RS-01-022

Subject: Revision D to Request for Technical Specifications Changes for Dresden Nuclear Power Station, Units 2 and 3, LaSalle County Station, Units 1 and 2, and Quad Cities Nuclear Power Station, Units 1 and 2, to Implement Improved Standard Technical Specifications

This letter submits further modifications for the proposed changes as Attachments 1, 2, and 3 to this letter. Each modification and its source is described in the "Summary of Changes" section of Attachments 1, 2, and 3. The sources include the changes made based upon discussions in meetings and telephone conferences between Exelon Generation Company (EGC), LLC, formerly Commonwealth Edison Company, personnel and the staff, and minor corrections to various sections of the proposed change. In addition, we provided comments concerning the draft Safety Evaluations (SEs) for the conversion to Improved Standard Technical Specifications in Reference 5. Attachment 4 provides a new comment on the draft SEs that was not previously submitted.

This attachment provides a brief summary of the changes in Revision D of the proposed Improved Technical Specifications (ITS) submittal for Dresden Nuclear Power Station, Units 2

2 INSERT B.1

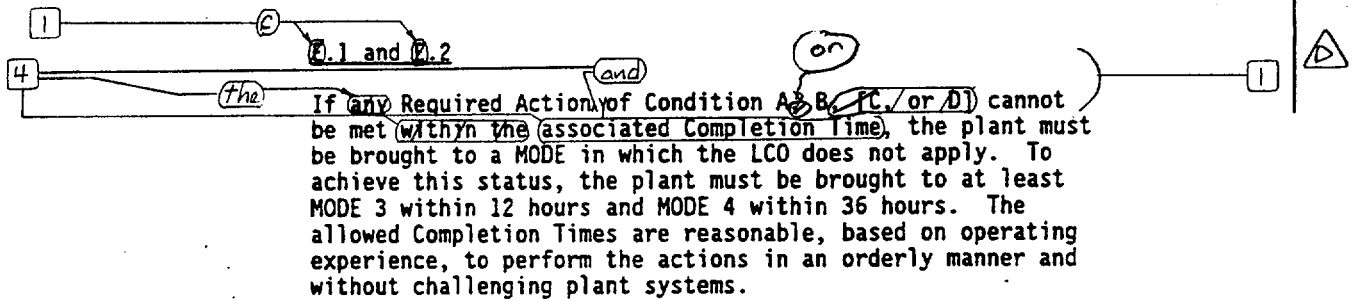
2. The primary containment atmospheric particulate sampling system has been added back into the ITS as requested by the NRC. This change affects the Split Report, Summary Disposition Matrix page 6, Appendix A page 11 of 16, and Appendix B page 3 of 5, ITS 3.4.5 pages 3.4.5-1 and 3.4.5-2 and Bases pages B 3.4.5-1, B 3.4.5-2, B 3.4.5-3, B 3.4.5-4, and B 3.4.5-5, the CTS markup for ITS 3.4.5, pages 1 of 2 and 2 of 2, the Discussion of Changes for ITS 3.4.5, DOC M.1 (page 1), DOC M.2 (page 1), DOC LA.1 (page 2) and DOC R.1 (deleted from page 2), the ISTS markup pages 3.4-12, 3.4-13, 3.4-14, and 3.4-15, the Justification for Deviations to ITS 3.4.5, JFD 4 (page 1) and JFD 5 (page 1), and the ISTS Bases markup pages B 3.4-27, B 3.4-28, insert page B 3.4-28, B 3.4-29, B 3.4-30, insert page B 3.4-30, B 3.4-31, and B 3.4-32.

With the primary containment atmospheric particulate sampling system inoperable, operation may continue for 24 hours. The 24 hour Completion Time of Required Action B.1 is acceptable, based on operating experience, considering the alternative form of leakage detection that is normally available and the fact that the LEAKAGE is still being determined every 12 hours (SR 3.4.4.1).

Insert SR Notes

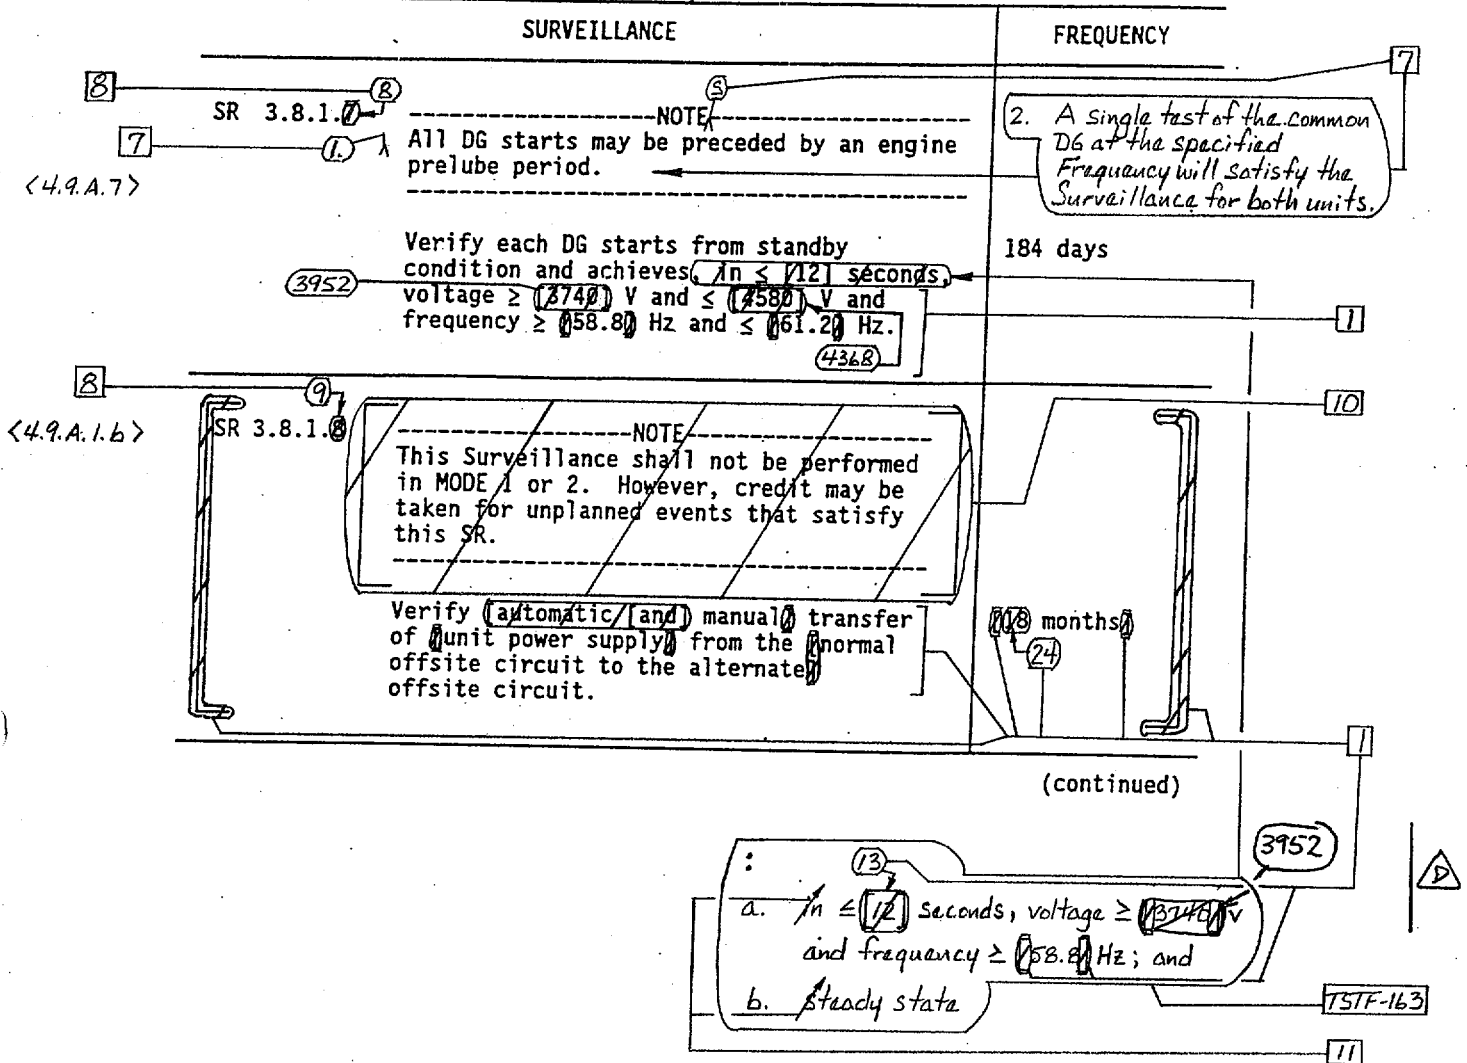
1. A typographical error in Note 1 of the Surveillance Requirements has been corrected (the term "SR" has been added before the second SR number). This change affects ITS 3.8.1 page 3.8.1-6 and the ISTS markup insert page 3.8-6.

1. SR 3.8.1.1 through SR 3.8.1.20 are applicable only to the given unit's AC electrical power sources.
  2. SR 3.8.1.21 is applicable to the opposite unit's AC electrical power sources.
-

Figure 3.1.7-1 (page 1 of 1)  
Sodium Pentaborate Solution Volume/Concentration Requirements

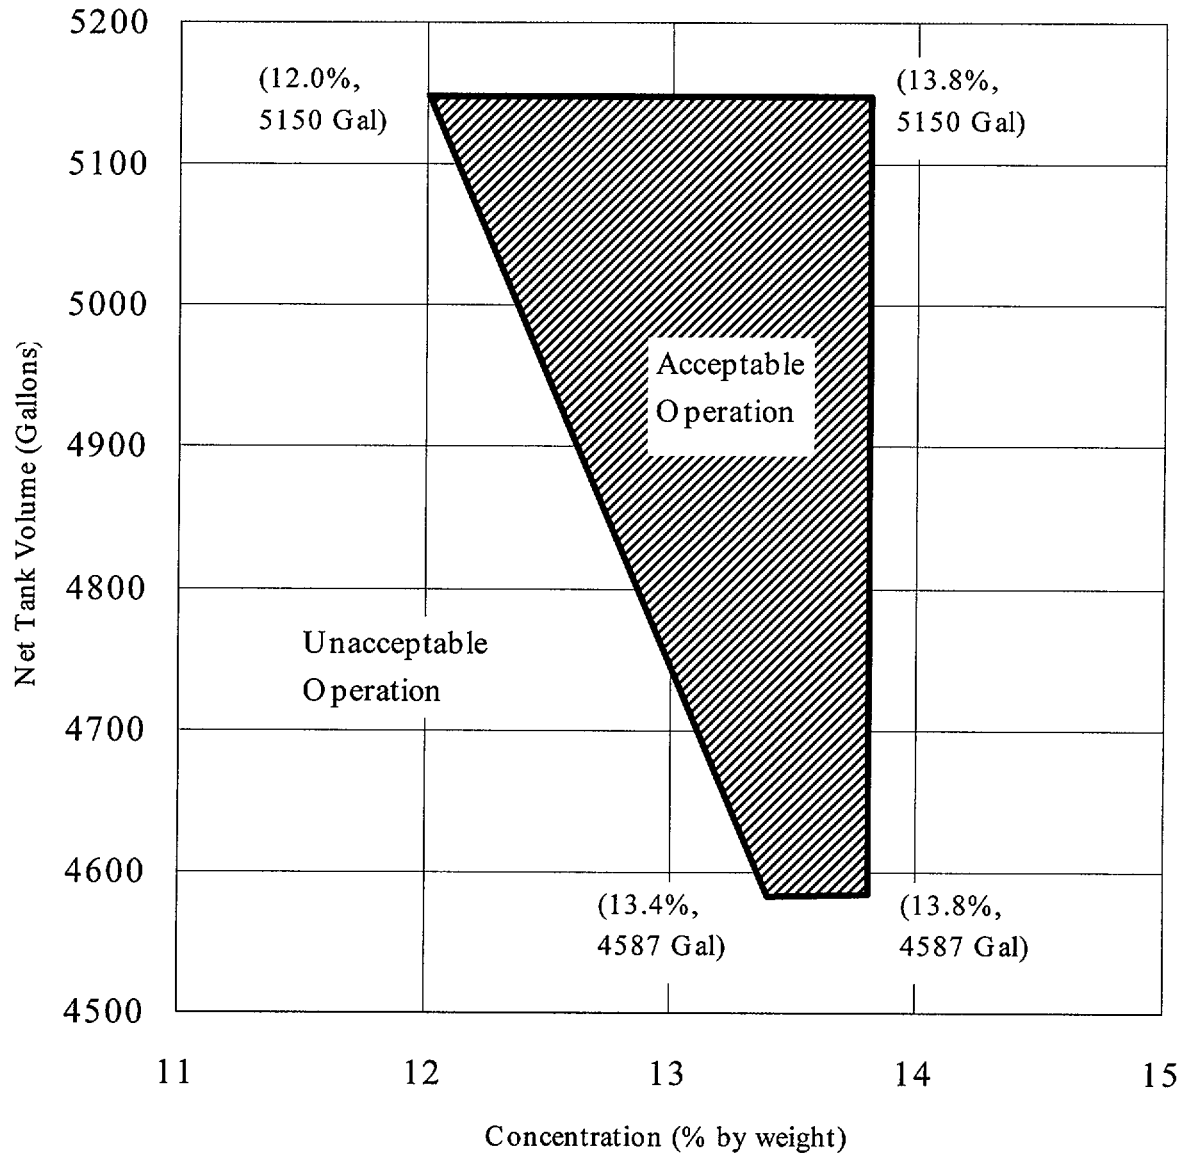
1. The word "boron" in the second Frequency in SR 3.1.7.5 has been changed to "sodium pentaborate" to be consistent with the words in the actual SR. This change affects the ISTS 3.1.7 markup page 3.1-21.
